Regular Planning and Zoning Board Meeting
At 6:00 PM

Meeting Date: March 10, 2026

B) PSPM26-0001 | TOMOKA HILLS GOLF COURSE SITE PLAN MODIFICATION #1 - A REQUEST BY NV5, INC. (APPLICANT/AGENT), ON BEHALF OF TOMOKA HILLS FARMS, INC. (PROPERTY OWNER) FOR A MODIFICATION TO CONDITION #1 OF THE TOMOKA HILLS GOLF COURSE SITE PLAN (PSP24-

C) PPP24-0004 | HIGHLAND HILLS MAJOR SUBDIVISION PRELIMINARY PLAT - A REQUEST BY EDA CONSULTANTS, INC. (AGENT) ON BEHALF OF 10.47 L.L.C. (PROPERTY OWNER) FOR THE HIGHLAND HILLS MAJOR SUBDIVISION PRELIMINARY PLAT WHICH PROPOSES THE SUBDIVISION OF LAND INTO 38 SINGLE-FAMILY DETACHED LOTS WITH ASSOCIATED COMMON AREAS AND RIGHTS-OF-WAY ON A ± 8.36-ACRE SUBJECT PROPERTY GENERALLY LOCATED SOUTH OF US HIGHWAY 441, BETWEEN INTERSTATE 75 AND NORTHWEST 147TH DRIVE, ALONG NORTHWEST 151ST BOULEVARD (TAX PARCELS: 03869-007-000, 03869-009-000 (PORTION THEREOF), AND 03869-010-000). FUTURE LAND USE: MEDIUM DENSITY RESIDENTIAL; ZONING: RESIDENTIAL MULTIPLE FAMILY – 8 (RMF-8) (QUASI-JUDICIAL HEARING).

Designed: SJR	Sheet No.: C110
Drawn: JB	
Checked: SJR	
Date: 01/07/26

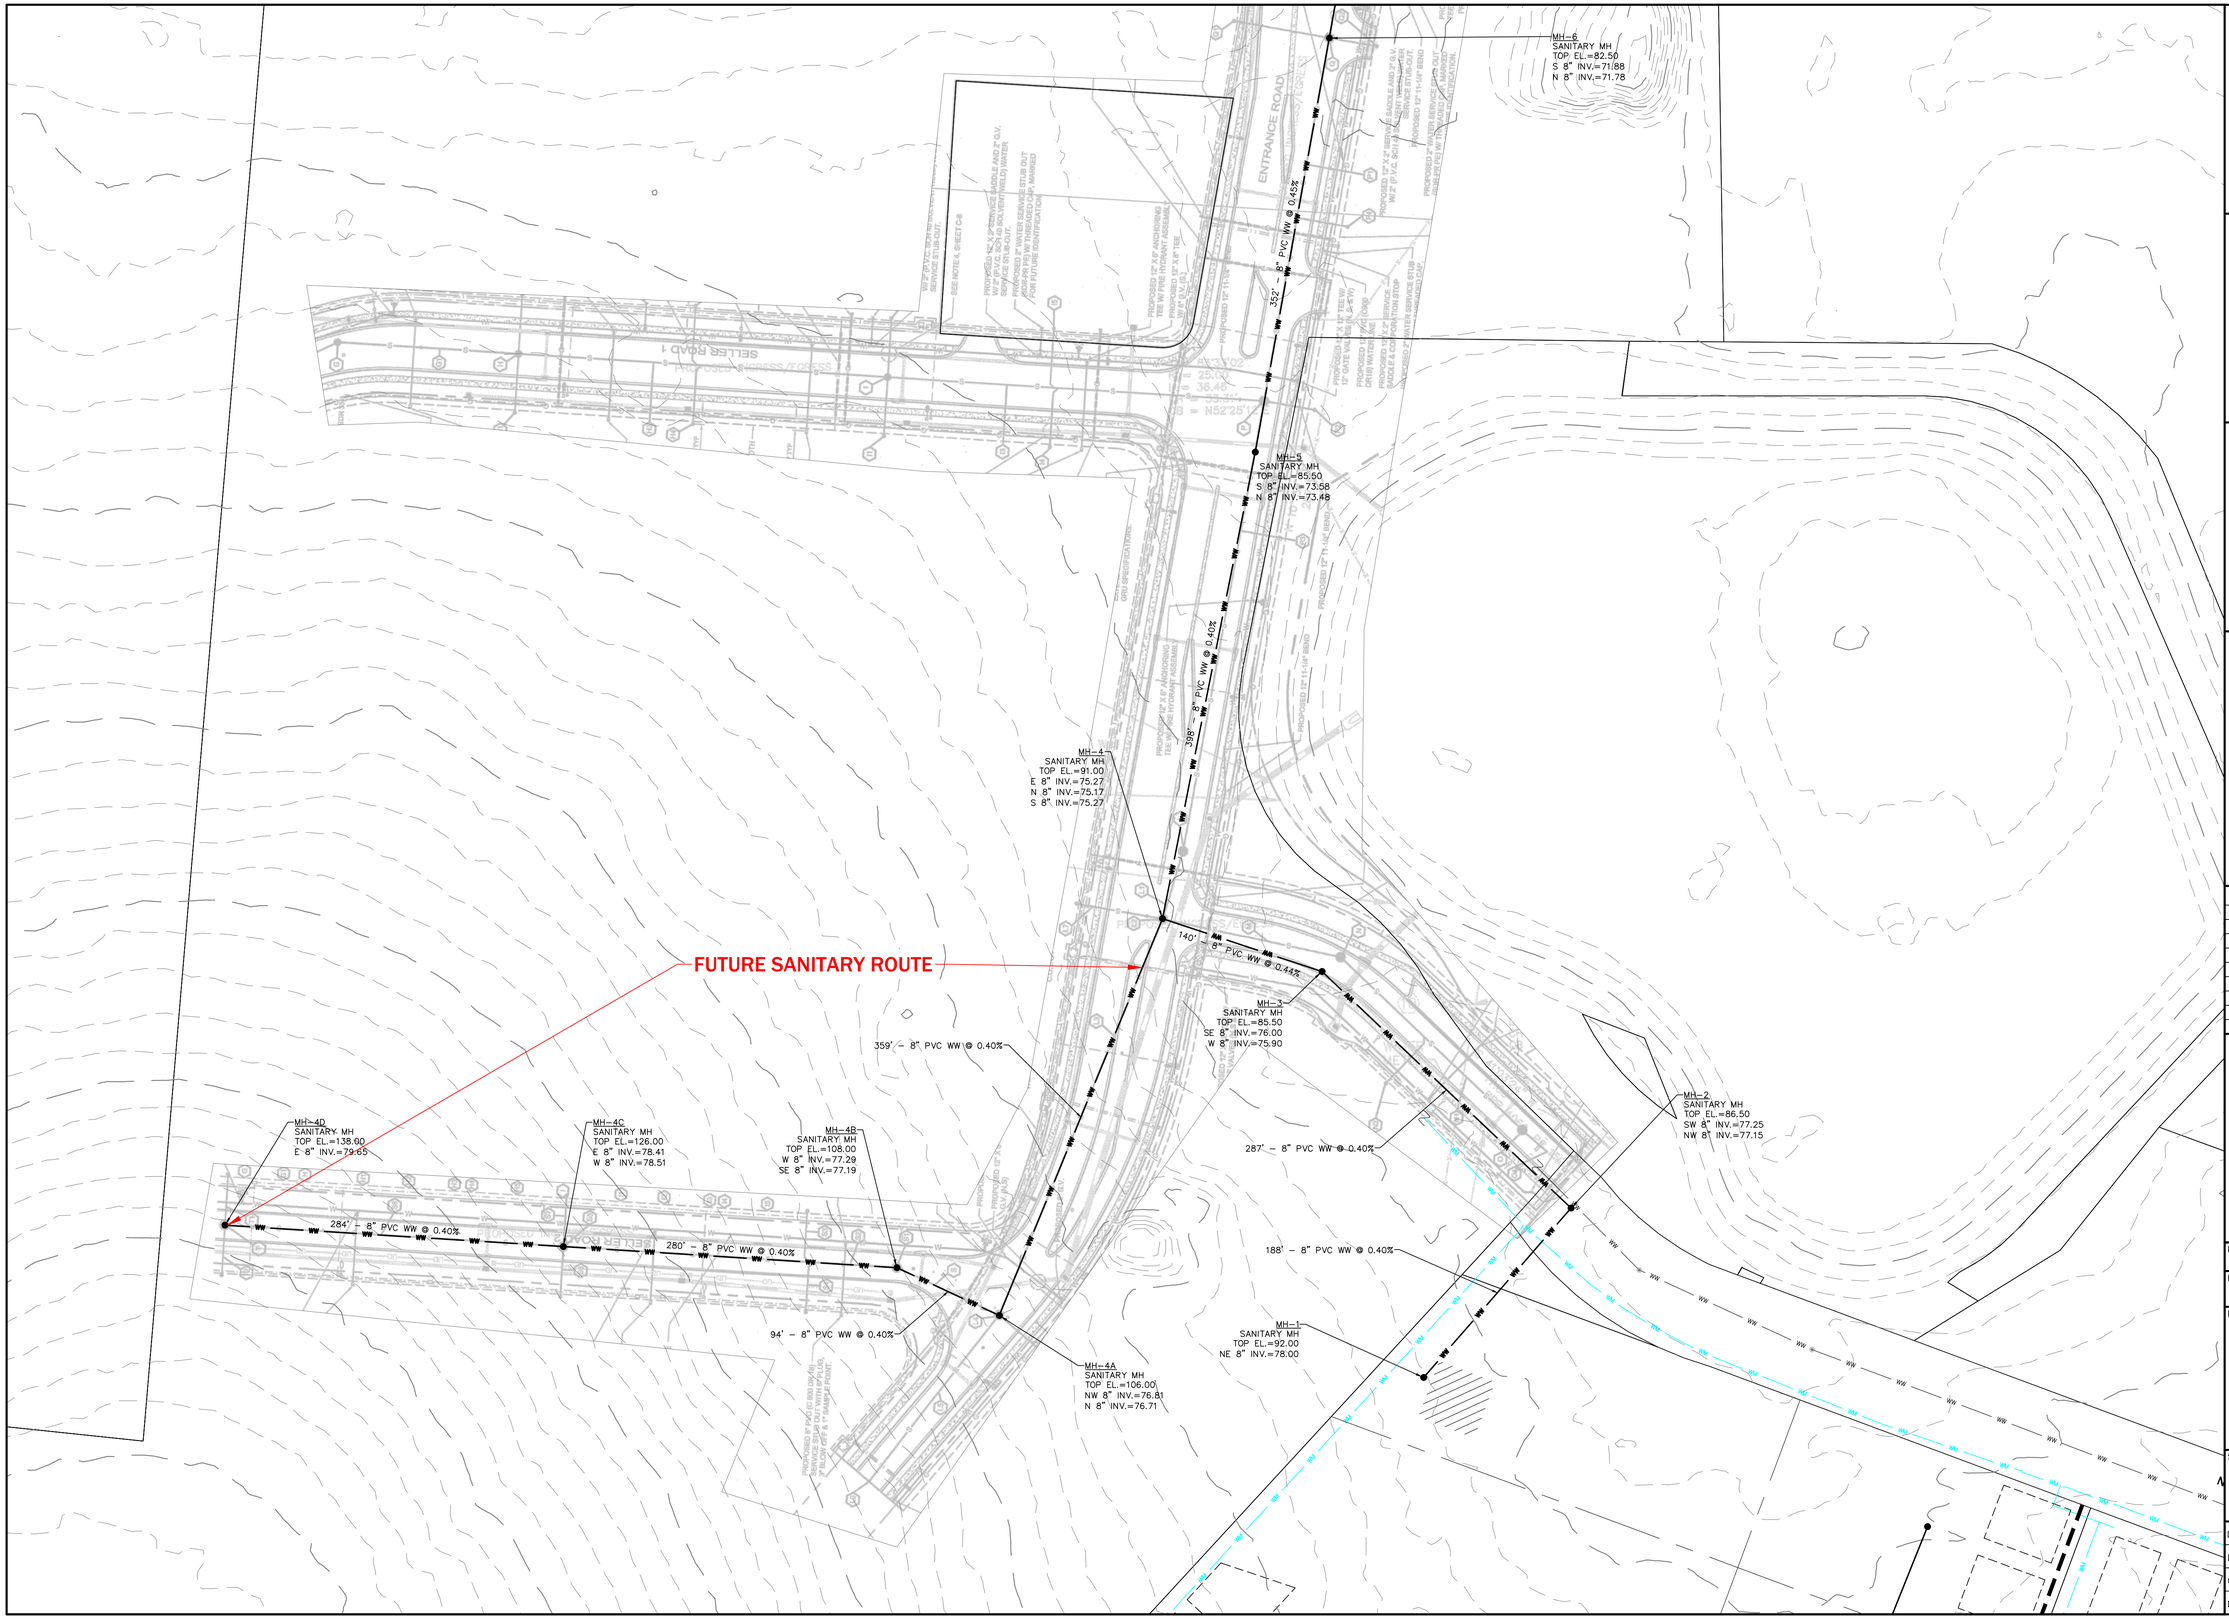
NO.	COMMENTS
	Approved **Comment on March Submittal** **Sheet C110** Please define "P.A.E.". Please **resubmit** this sheet.
2	**Comment on May Submittal** **Sheet C400** Please change force main abbreviation from "WW" to "FM". Please **resubmit** this sheet. **Comment on July Submittal** **Sheet C400** **Approved**
3	**Comment on May Submittal** **Worksheet for Needed Fire Flow** Required fire flow is 1500 gpm. Please **submit** response as to how this required fire flow will be verified; for example, fire flow test. **Comment on July Submittal** Engineer indicated that fire flow results will be provided as part of construction plans. **Approved**
4	**Comment on May Submittal** **Lift Station Basin Analysis** Please change peaking factor from "2.5" to "4.0". A peaking factor of 4.0 is now standard for COA. Please **resubmit** lift station pump calculations.

c. Review and address comments from Alachua County Fire Rescue dated 06/18/2024 (attached).
5. Miscellaneous
   a. Sheet C110 omits some public utility easement (PUE) lines and setback lines on the western lots.

Sheet No.: C450

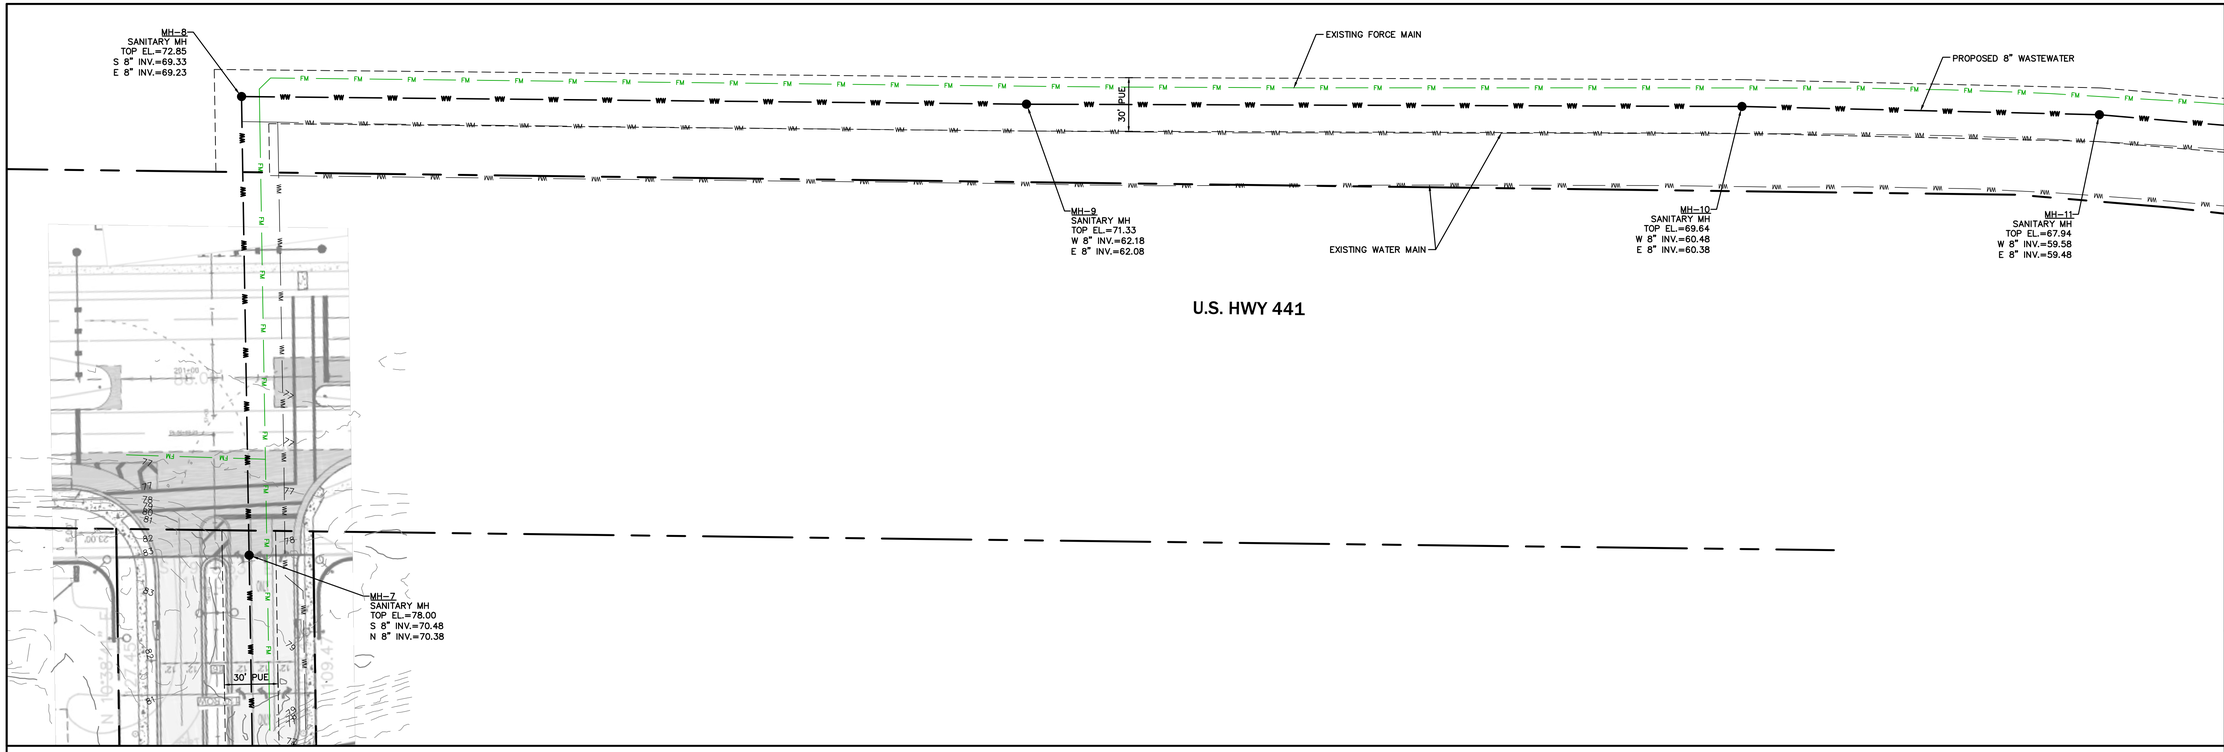
MH-7 on submitted sheet C450 is only 4 feet deep, while MH-R, whose location is similar to MH-7, is about 20 feet deep as per Walmart sheet C-8A.
